To: Planning Committee
From: Wayne Craig
Director, Development

Date: May 3, 2021
File: RZ 18-831725

Re: Application by Kadium No. 4 Development Ltd. for Rezoning at 10340, 10360, 10380, 10400 and 10420 No. 4 Road from the "Single Detached (RS1/E)" Zone to the "Medium Density Townhouses (RTM2)" Zone

Staff Report

DRAWING TITLE:
TREE MANAGEMENT PLAN

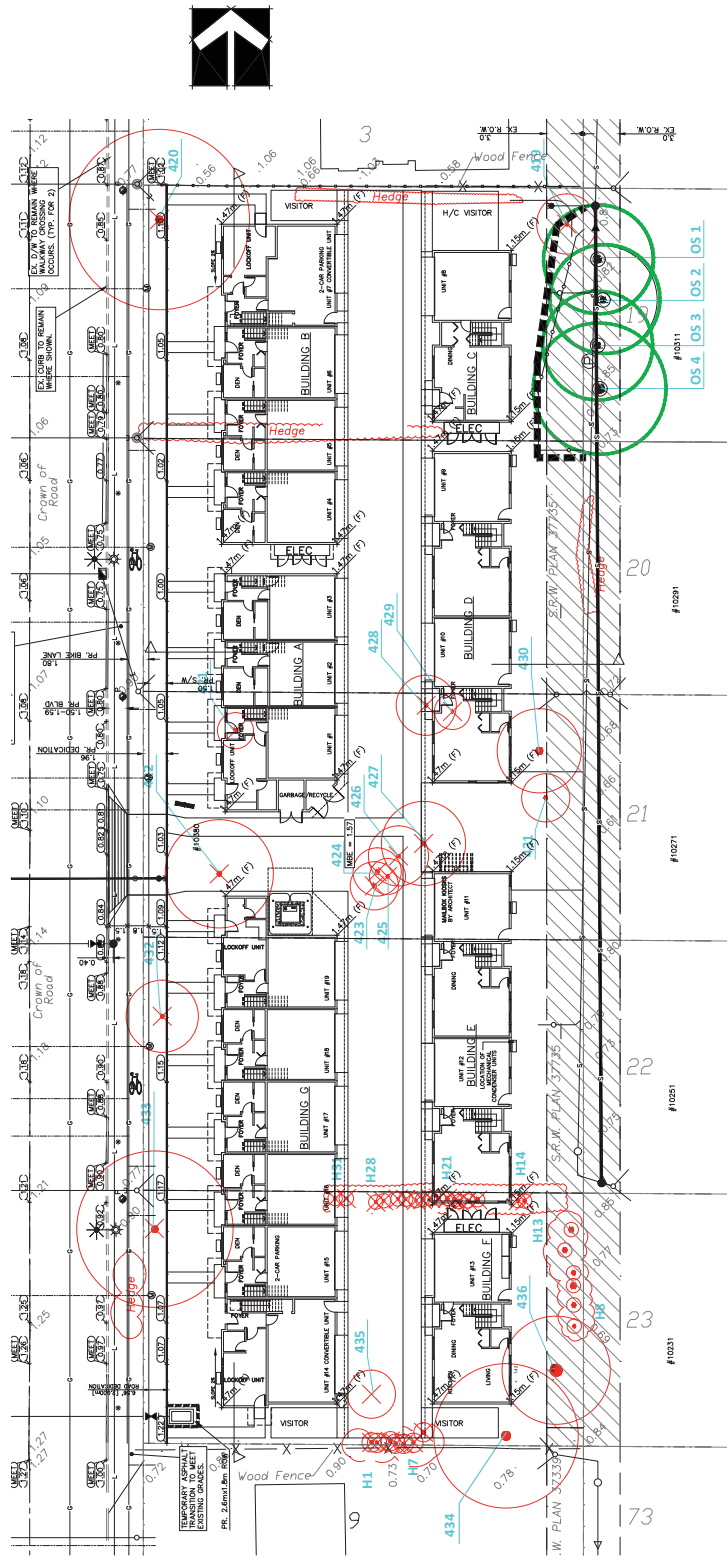
The City's Tree Preservation Coordinator has reviewed the Arborist's Report and supports the Arborist's findings, with the following comments:

- There are 18 on-site trees:
 - Three trees are located within the proposed road dedication area and are in poor health. Tree #420 (a Cedar tree) has a significant lean to the south, this tree has also been Hydro pruned for overhead line clearance, resulting in an unbalance canopy (heavy in the direction of the lean). Tree #432 (a Cherry tree) is in very poor condition as the tree has poor vigor and health, sparse foliage, and has been previously topped and bark is crumbly. Tree #433 (a Norway Maple tree) has a twin stem with a crack in the trunk that extends to the base. Approximately a third of its canopy has been removed by BC Hydro for Hydro line clearance. The health of these trees and the requirements for frontage improvements and continual canopy removal by BC Hydro for line clearance do not make these trees candidates for retention and they should be replaced.

- Four trees (#419, #430, #431 and #436) are located within the rear yard, all of which are in poor condition, in conflict with the required sanitary sewer upgrade and should be removed.

- 11 other on-site trees:
 - Two trees are proposed to be relocated within the site:
 - Tree # 422 (a Japanese Maple tree) and #435 (a Japanese Snowbell tree) are in good condition and located within the driveway. However, the applicant has agreed to relocate these trees to or near the shared outdoor amenity area in order to retain them. These trees are identified on the marked-up Tree Management Plan that is provided on Attachment 5.

- Eight on-site trees (#421, #423 - #426, #428, #429, and #434) would be removed and replaced, due to their poor condition.

- One tree (#427; a Japanese Maple tree) is in good condition but needs to be removed as the site geometry, site access requirements and the tree’s size prevent its retention in its current location or its relocation within the site.

- There are several hedges on-site, none of which are subject to the tree bylaw.
 - Hedge H1-H7 is located along the south property line. This hedge is to be retained and, through the Development Permit process, would be determined to either remain in its existing location (as a visual terminus to the interior driveway) or be relocated to elsewhere along the south lot line (to serve as screening from the adjacent lot to the south). This hedge is identified on the marked-up Tree Management Plan that is provided on Attachment 5.

- All other on-site hedges are located along existing property lines or within the sanitary SRW and are not in good condition, and should therefore be removed.

- There are four mature off-site trees (Tags# OS1, OS2, OS3 and OS4) located on an adjacent neighbouring property (10311 Dennis Crescent) and within an existing sanitary SRW are to be retained and protected, and tree protection must be provided as per City of Richmond Tree Protection Information Bulletin Tree-03.

Considering that the four off-site trees are located within an existing SRW, within which the sanitary infrastructure requires replacement, the project arborist should work with City Engineering staff to coordinate methods for minimize harm to the tree during infrastructure works within the Tree Protection Zone. In the event that City staff are unable to accept the arborist’s methods for works within the Tree Protection Zone, the applicant should either:

- Provide additional SRW area for the sanitary sewer line in order to accommodate a diversion around the dripline of the subject trees.
- Coordinate an alternative solution that is acceptable to City Engineering staff.
- Obtain permission from the owner of the subject trees in order to remove them and provide replacement trees in accordance with Tree Protection Bylaw No. 8057.

The applicant proposes to remove 16 on-site trees (Trees # 420, 421, 432, 433, 434, 436, 423, 424, 425, 426, 427, 428, 429, 430, 431 and 419). The 2:1 replacement ratio would require a total of 32 replacement trees. The applicant has agreed to plant 36 trees on the development site; for a total of 38 trees, including the relocated trees. The required replacement trees are to be of the following minimum sizes, based on the size of the trees being removed as per Tree Protection Bylaw No. 8057.

Four mature off-site trees (Tags# OS1, OS2, OS3 and OS4) located on an adjacent neighbouring property (10311 Dennis Crescent) and within a sanitary SRW should be retained and protected. As such, the applicant would be required to complete the following items to ensure that the subject trees are protected at development stage:

- Prior to final adoption of the rezoning bylaw, submission to the City of a contract with a certified arborist for the supervision of all works conducted within or in close proximity to tree protection zones. The contract must include the scope of work required, the number of proposed monitoring inspections at specified stages of construction, any special measures required to ensure tree protection, and a provision for the arborist to submit a post-construction impact assessment to the City for review.

- Prior to demolition of the existing dwelling on the subject site, installation of tree protection fencing around all trees to be retained. Tree protection fencing must be installed to City standard in accordance with the City's Tree Protection Information Bulletin Tree-03 prior to any works being conducted on-site, and remain in place until construction and landscaping on-site is completed.
